37701A-06

S E R V I C E N O T E

HP 37701A T1 Tester

New firmware fixes fatal error 421 when printing Datacom Graph

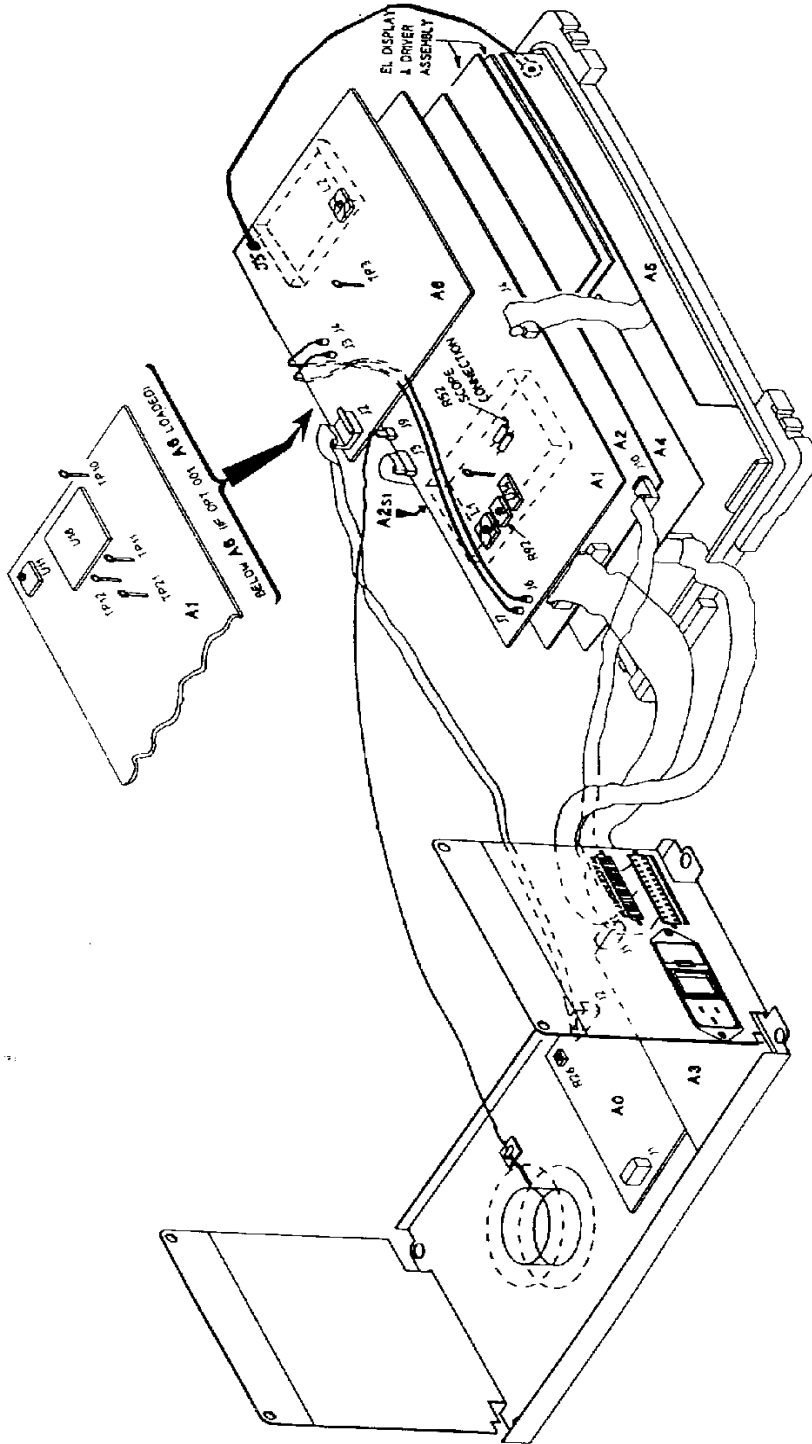
Replace Processor Assembly A2 Prom parts 37701-80025 (A2U2) and 37701-80027 (A2U57) with HP part numbers 37701-80035 and 37701-80037 respectively. Use the following procedure for PROM replacement.

1. Use the Component Location layout to identify the parts to be replaced (fitted on sockets) and remove the existing A2U2 and A2U57 parts.
2. Fit the new Proms as follows: A2U2 - 37701-80035, A2U57 - 37701-80037.
